PIC18CXX2 Rev. B Silicon/Data Sheet Errata

The PIC18CXX2 (Rev. B) parts you have received conform functionally to the Device Data Sheet (DS39026C), except for the anomalies described below.

In the Device Data Sheet (DS39026C), the following clarifications and corrections should be noted.

FIGURE 21-3: PIC18CXX2 VOLTAGE-FREQUENCY GRAPH (EXTENDED)

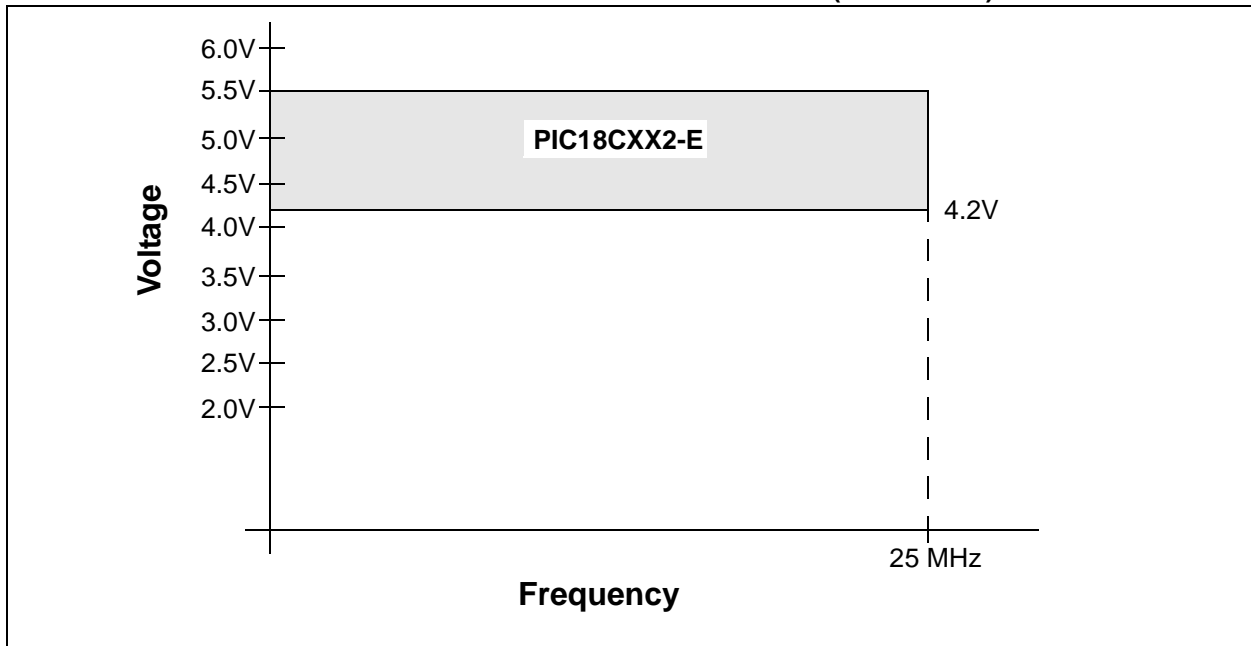
The operating frequency range for extended temperature devices has been changed.

The maximum external clock frequency (EC and ECIO modes) and oscillator frequency (HS mode) for extended temperature devices has been changed to 25 MHz. When the PLL is used

(HS+PLL mode), the maximum clock and oscillator frequency has been changed to 6.25 MHz. Other values of related parameters have changed accordingly.

Figure 21-3 (below), reflecting the voltage-frequency performance of extended temperature devices, is added to the Device Data Sheet:

FIGURE 1: INTERRUPT LOGIC (EXCERPT)

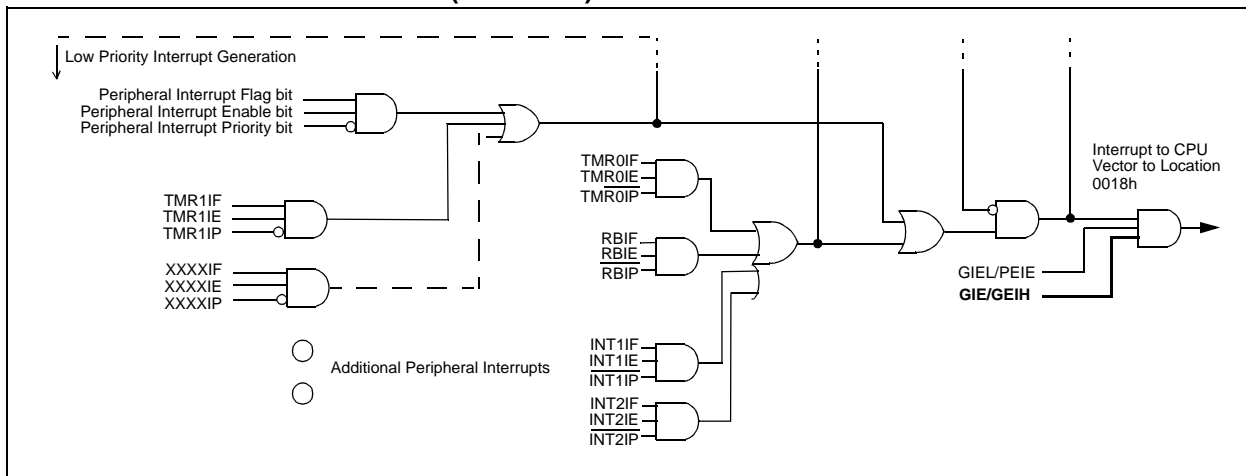
The operation of the GIE/GIEH bit (INTCON<7>) is clarified as follows: when the bit is cleared, all interrupts are disabled. This is regardless of the state of the IPEN bit (RCON<7>), the priority of the interrupt, or whether or not the interrupt is unmasked. This varies from the original description, in which clearing the bit when IPEN = '1' would only disable high priority interrupts.

Also, the interrupt logic funnel shown in Figure 7-1 of the Device Data Sheet is amended with the addition of a GIE/GIEH control line, as shown in Figure 1 (new material in **bold line**).
